Development Review Division

DATE: March 4, 2021

SUBJECT: SP20-081 New Horizon Daycare Site Plan – Planning Review 2

LANDSCAPE PLAN

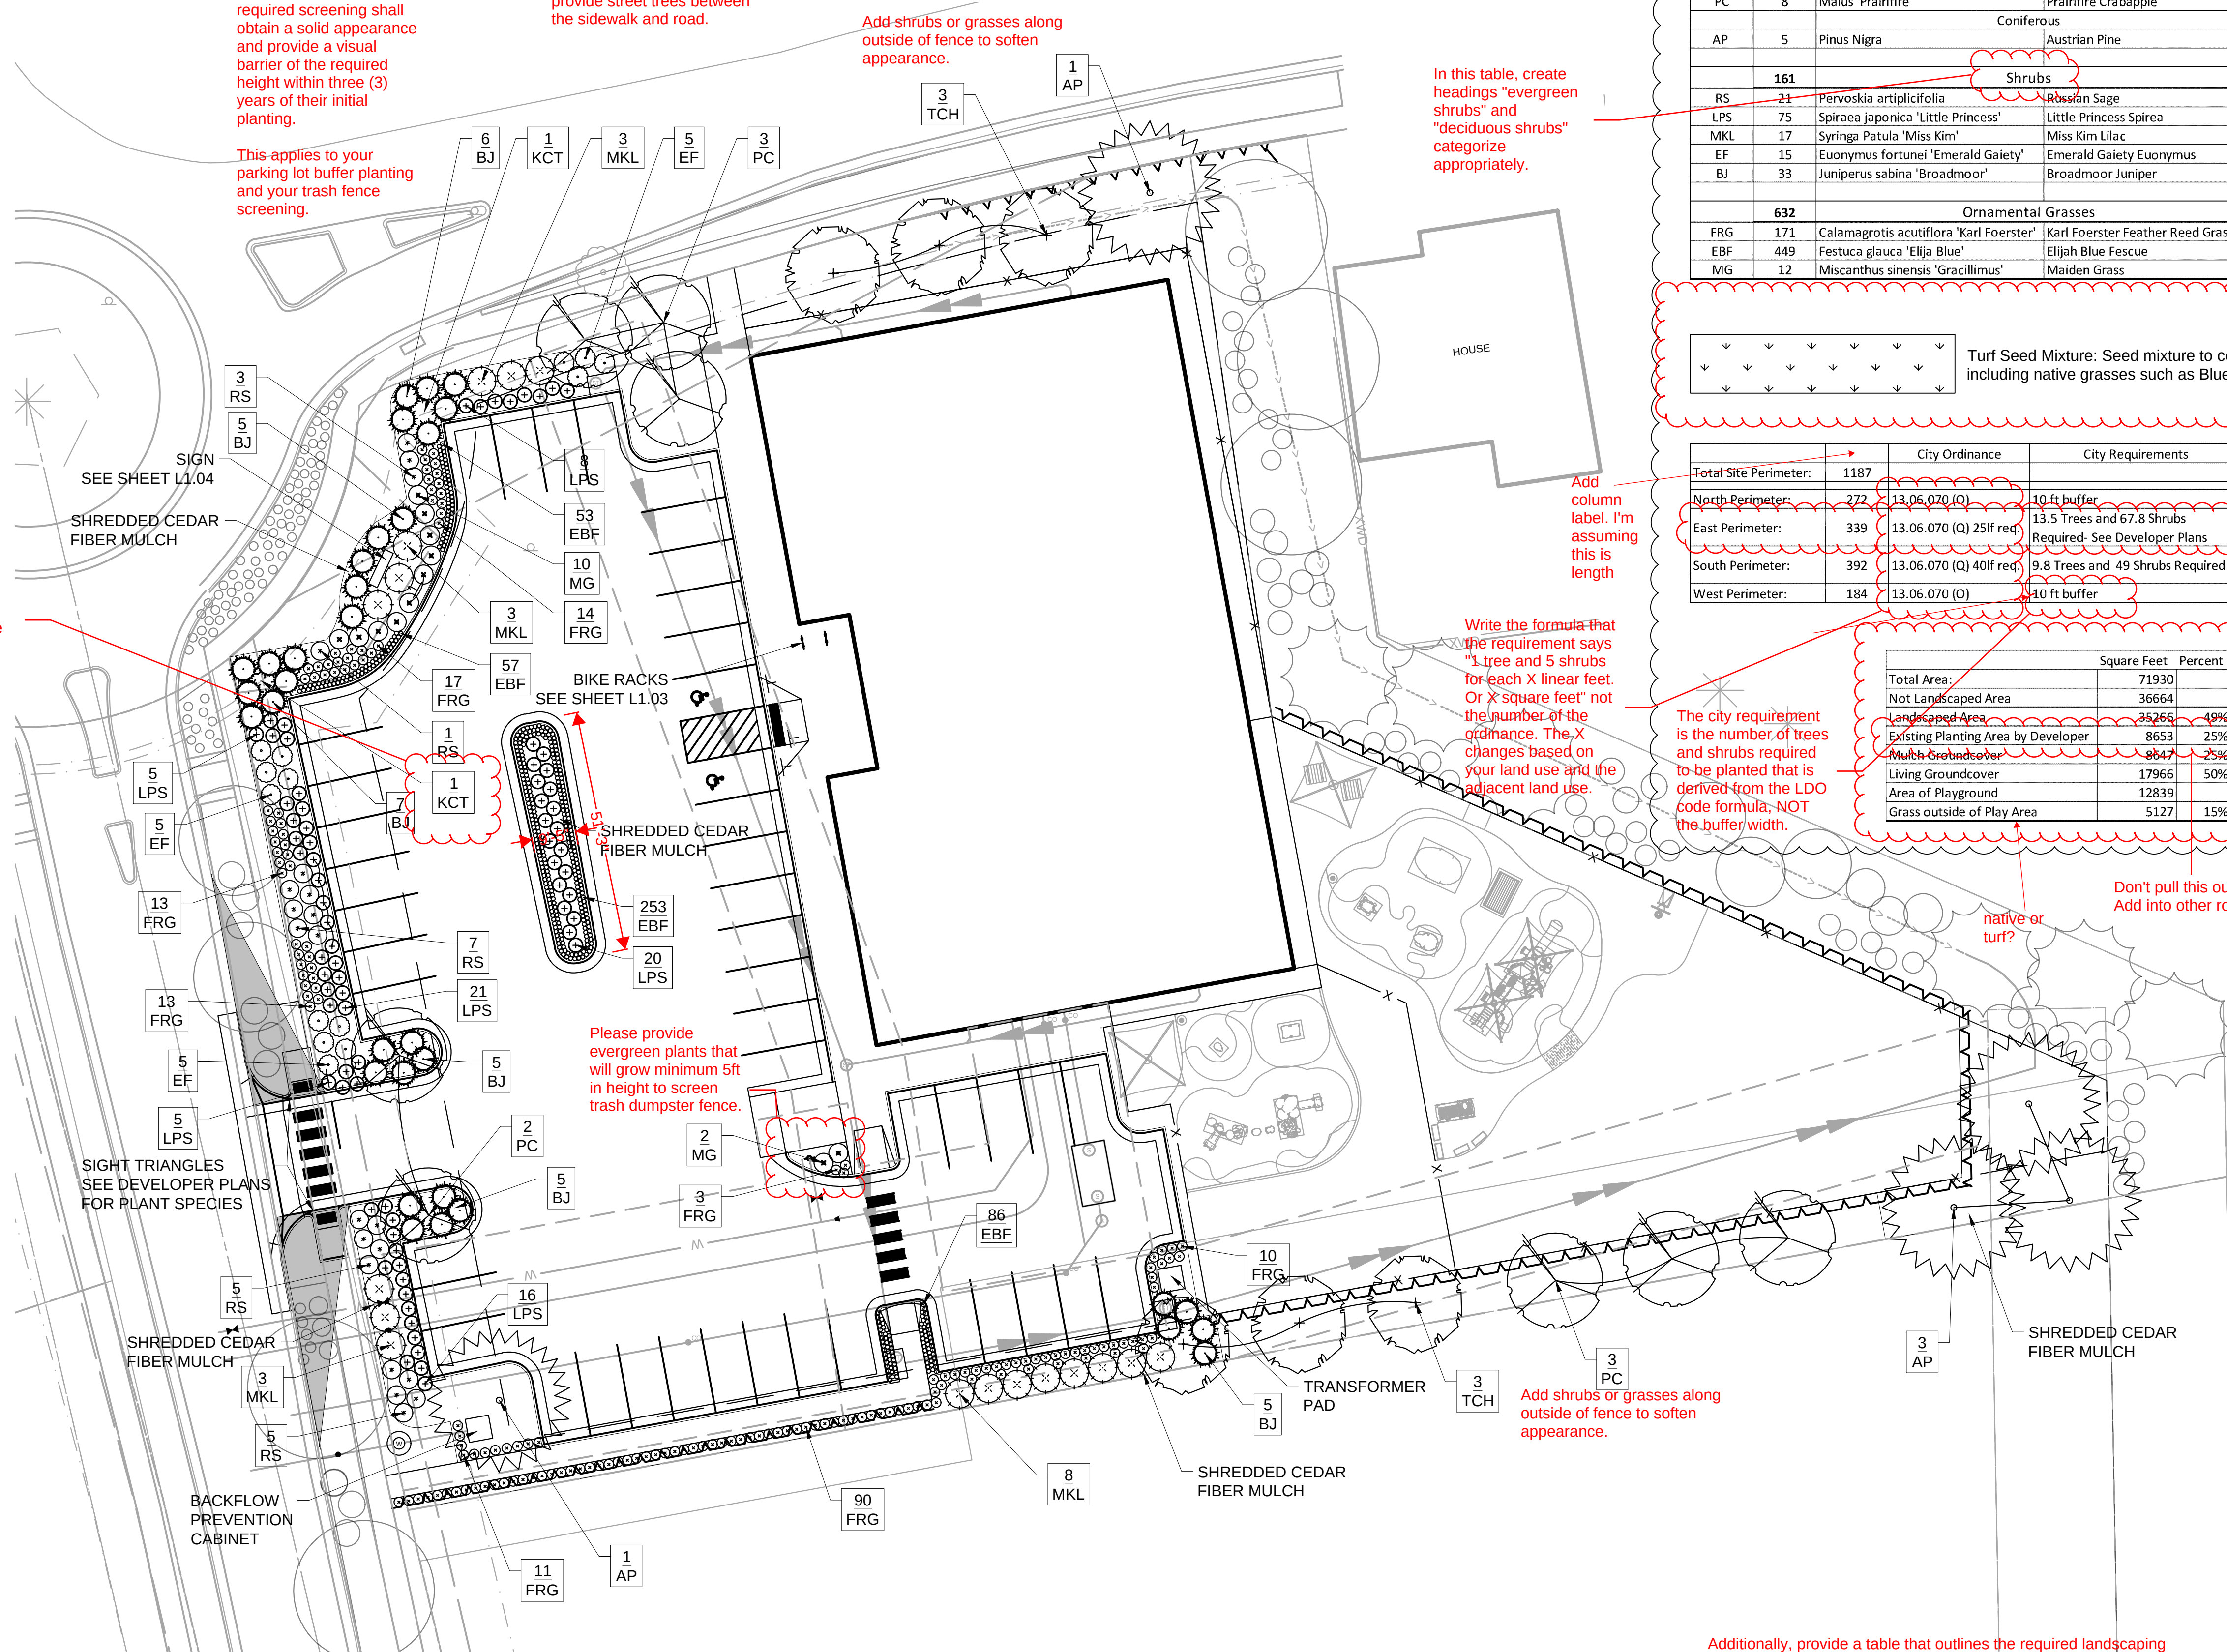
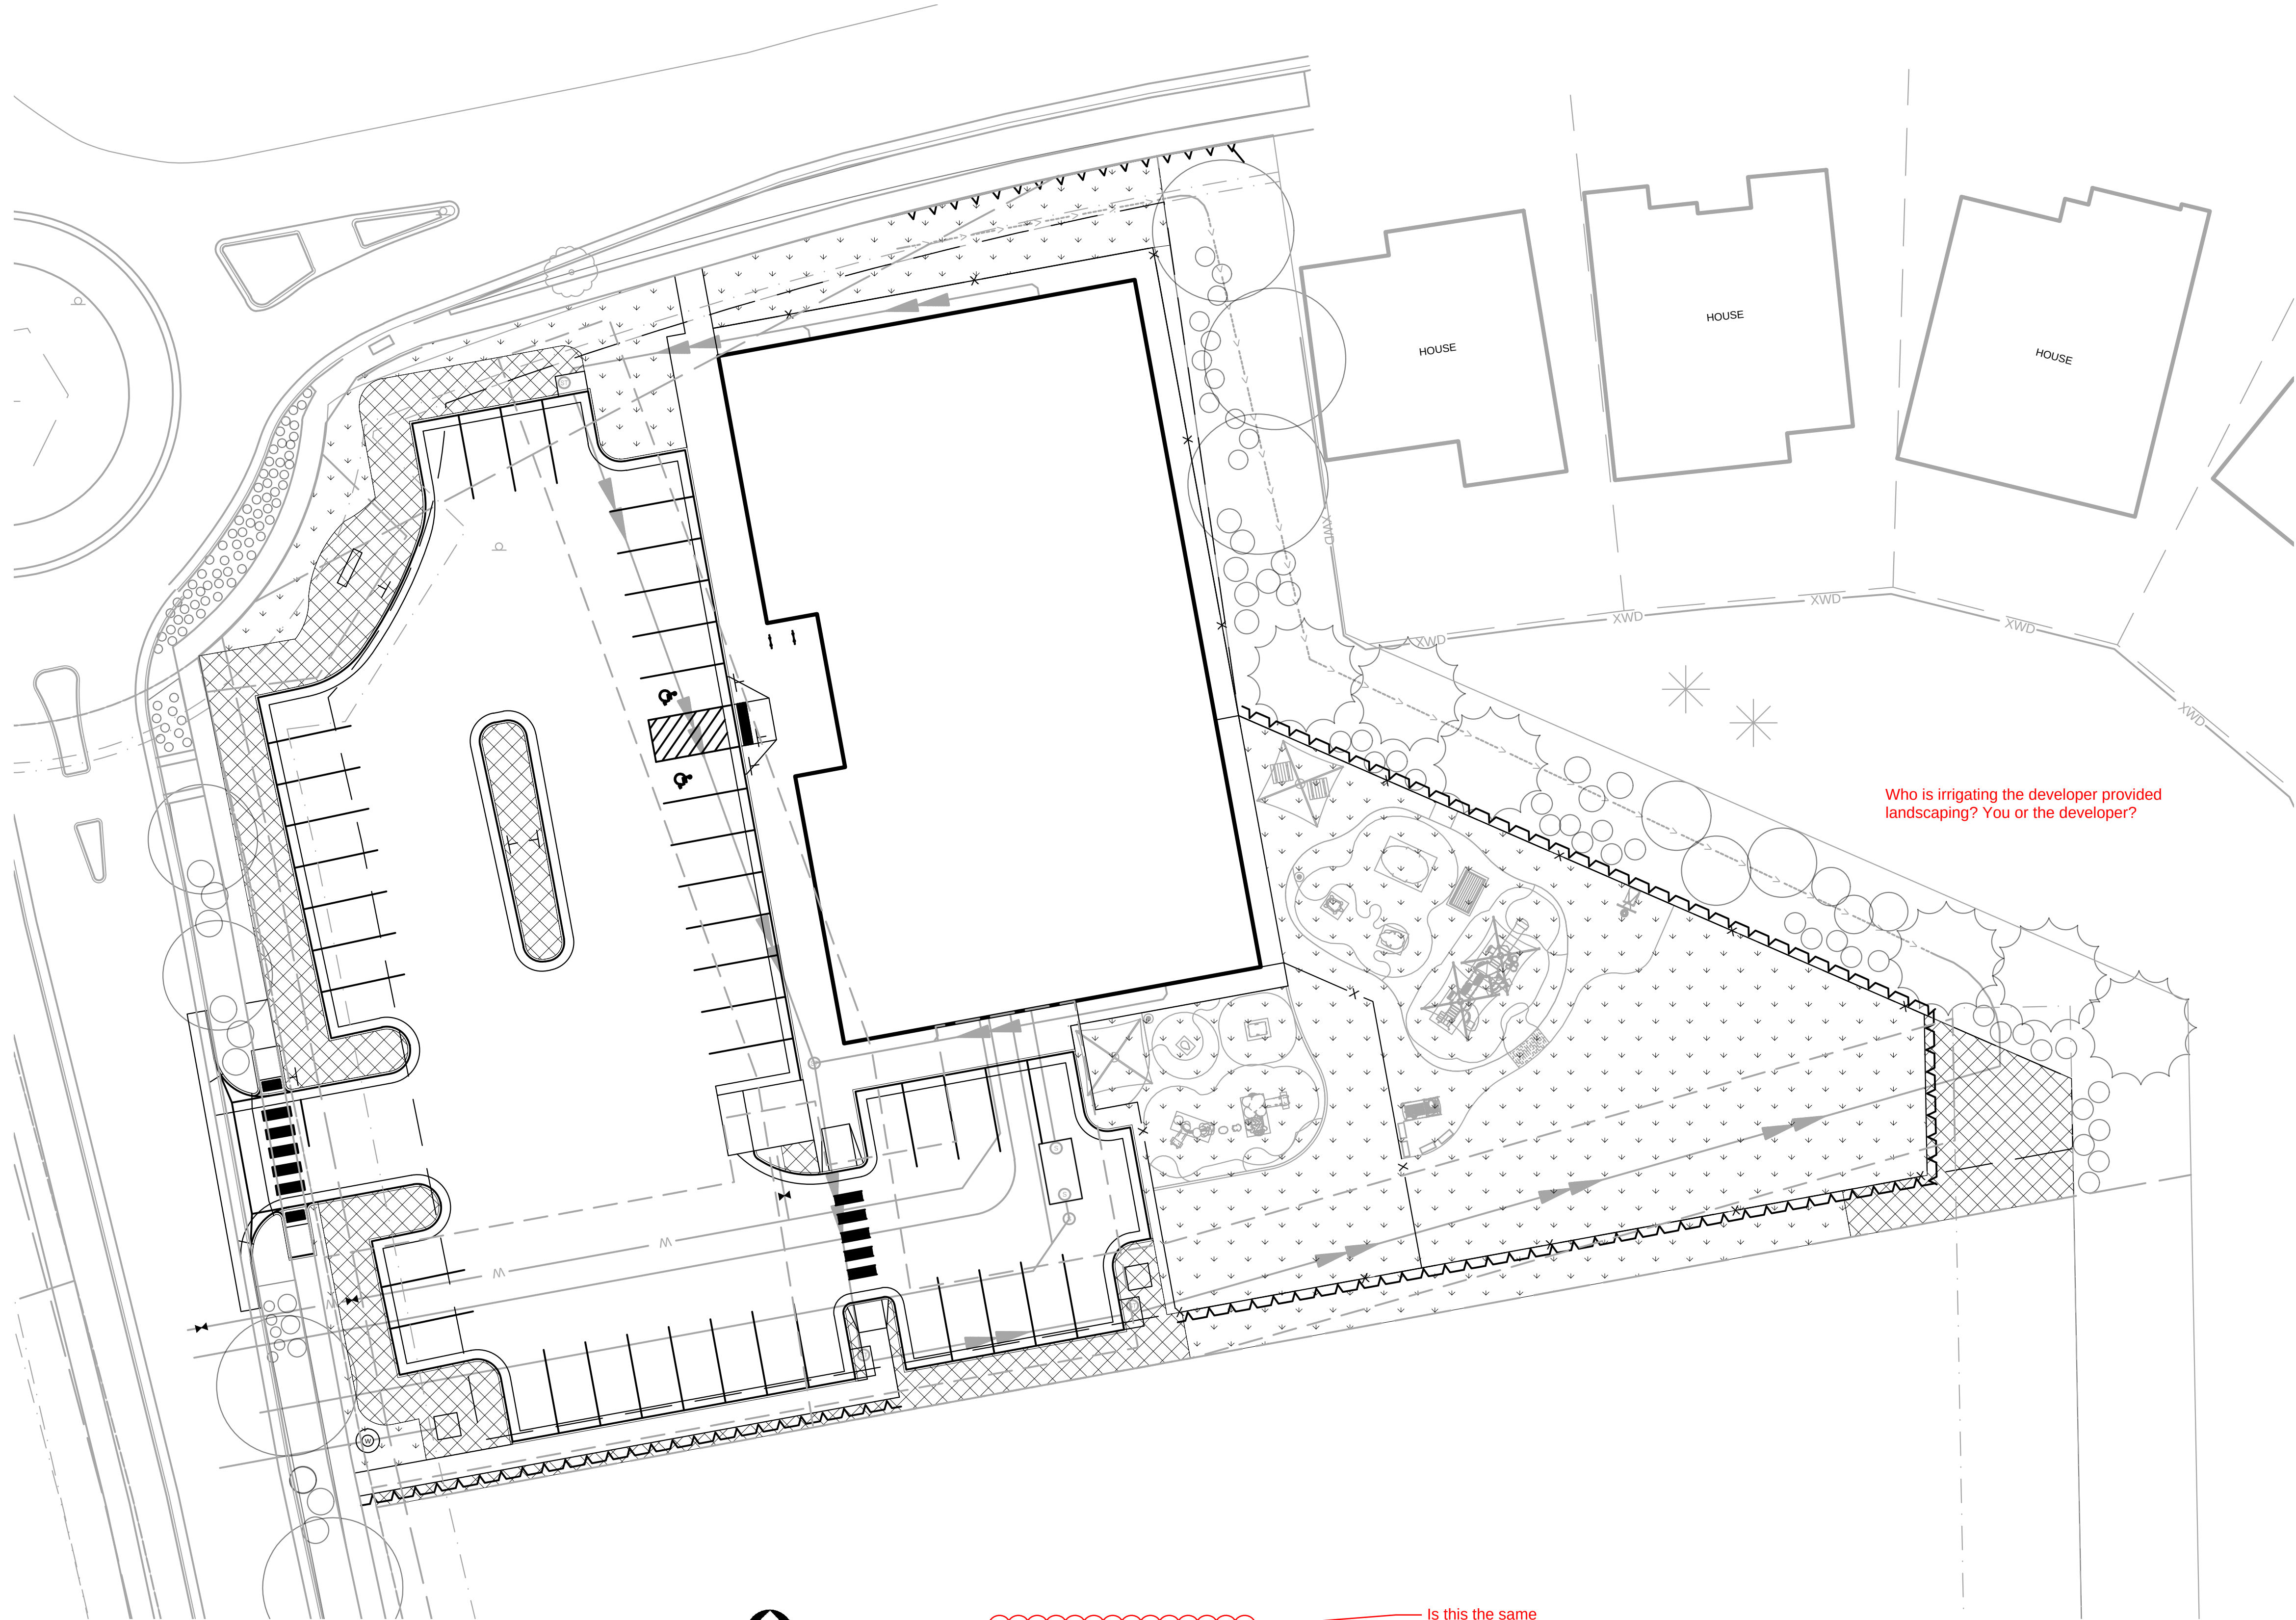
(4)Each landscape island shall, at a minimum, meet the following standards:a.Landscaped islands shall be at least the size of one (1) full-sized parking space (one hundred sixty-two [162] square feet) and have no dimension fewer than nine (9) feet.b.One (1) tree and five (5) shrubs shall be planted for each incremental one hundred sixty-two (162) square feet. For each incremental fifteen (15) square feet, an additional shrub shall be planted. One (1) tree may be substituted for ten (10) shrubs when approved during the site plan process.

Because of this, you need to plant three trees and 15 shrubs in your parking island.

Add requirement, formula, and provided trees and shrubs to your data table.

Plant materials used for required screening shall obtain a solid appearance and provide a visual barrier of the required height within three (3) years of their initial planting.

This applies to your parking lot buffer planting and your trash fence screening.

Is the developer planting street trees along this edge? If not, you will need to provide street trees between the sidewalk and road.

Add shrubs or grasses along outside of fence to soften appearance.

Add a separate table for the developer planter planting information that is the same as the table requirements for your own planting, aka, city requirement of quantity, and quantity provided, and species list.

Add column for adult height and water usage. Please select plants from the Towns Xeriscape plants list.

Add three rows to table for total trees and shrubs provided on site. Daycare provided total developer provided total combined provided total

Add row for overall site minimum landscaping city requirement and formula you used to derive it.

Add row for evergreen to deciduous ratio for site perimeter landscaping AND overall site landscaping

Texture not shown on this page. Provide ACTUAL seed mixture and percentages of each species within the mixture.

Add developer information here. Do not

Add column that includes the actual city requirement for that perimeter, 1 tree and 5 shrubs for every X linear feet depending on the neighboring use.

If you are specifying actual turf and not native seed areas with this. A maximum of 15% of your landscaped area may be turf (13.06.060 F.1.A). You can subtract the area of the playground from that ratio. If you wish to go that way, please call out the square feet of site that contain the playground. List the square feet of site that will be covered in turf and what proportion of the landscaped area that is. Specify the full list of species in the turf mix. This is the exact language from our code, so I can't tell if this is what you are actually planting.

Create new sheet that shows location of all ground covers: mulch, rocks, sod, native, grasses etc. Use textures not arrows. Include data table AND legend on this sheet. What is the percentage of site covered in turf grass? Both inside and outside the playground

Don't pull this out. Add into other rows.

native or turf?

Additionally, provide a table that outlines the required landscaping verses what is being provided for shrubs, grasses and trees. Please refer to Section 13.06.070(i)(5). Provide a table showing the required site perimeter trees and shrubs verses what is being provided. Include the total percent of evergreens being provided. Please refer to Section 13.06.070(p). Please note street trees are not included in the site perimeter requirements. Provide a table showing the required parking lot buffer trees and shrubs verses what is being provided. For all, include the value of the area or length that you used to arrive at what was required.
